Storm Drainage Calculations

Wal-Mart Expansion
University Village Shopping Center
Evansville, Indiana

Partnership Engineering

12-10-93

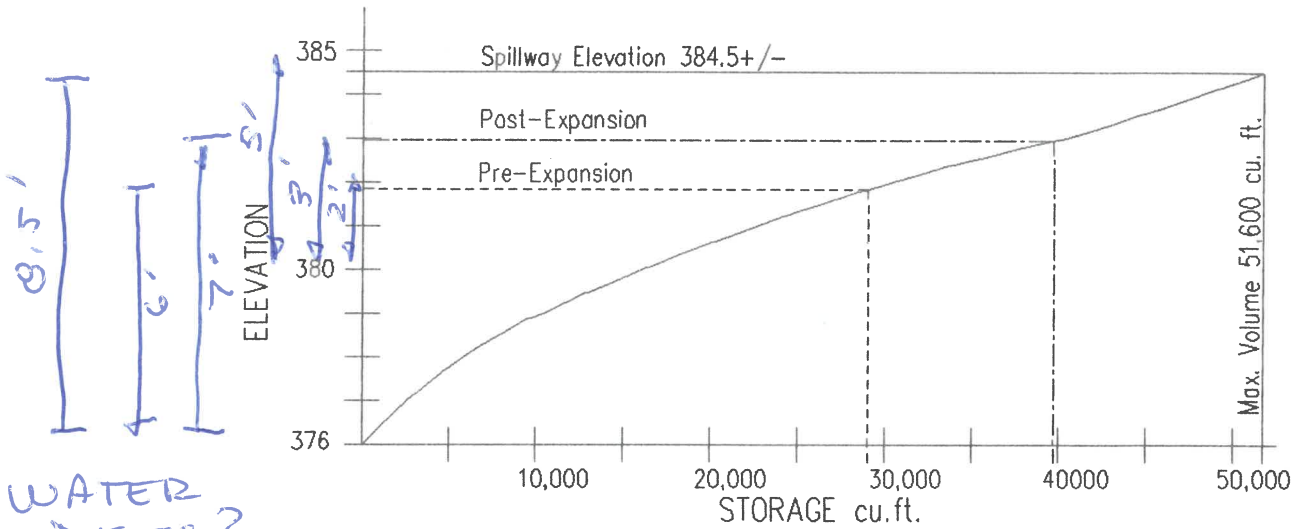
WHY DIFFERENT?

increase impervious = 2 AC

DIDNT USE IT ANYWAY?

WATER DEPT'S ?

STAGE-STORAGE CURVE

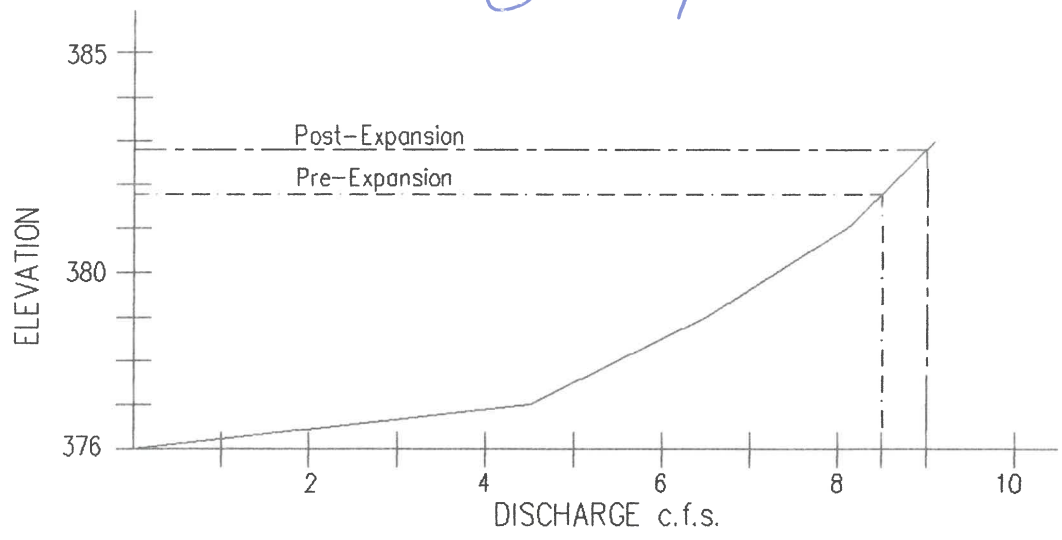
- ① IS POND BOTTOM 376 OR 380
- ② IS POND BOTTOM "DRY"

EXISTING DENTION AREA
N.T.S.

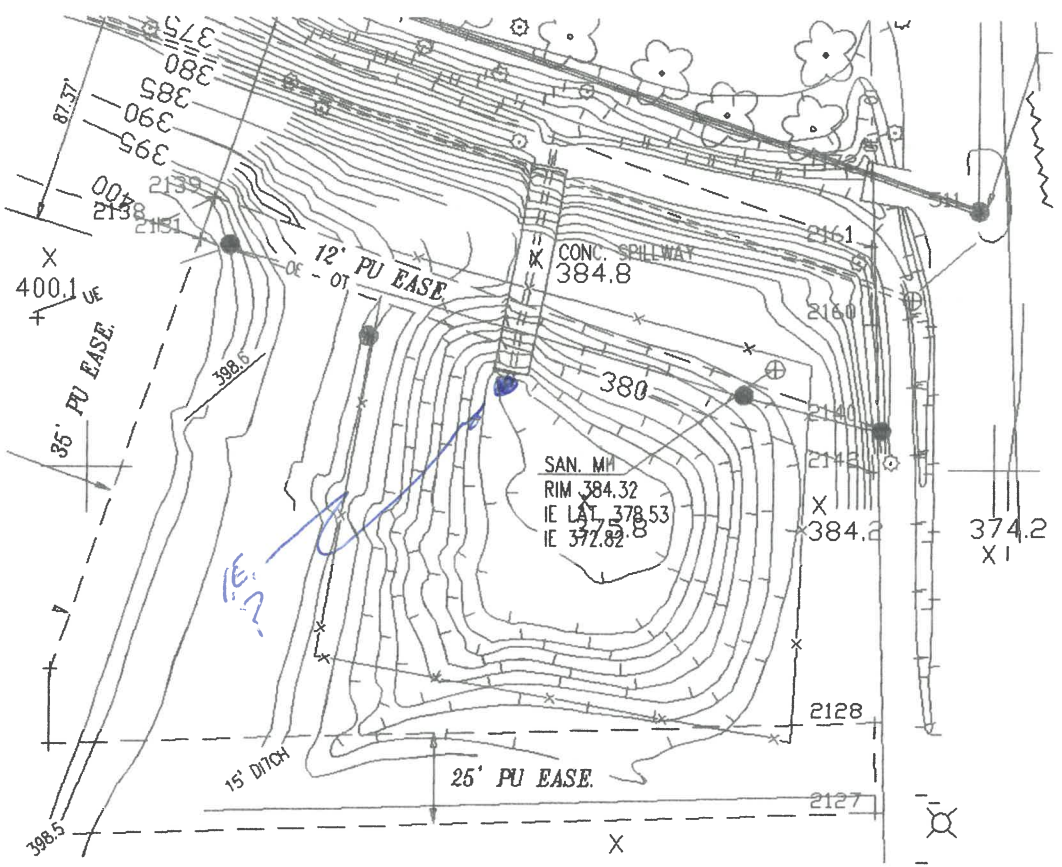
*see
pg 4*
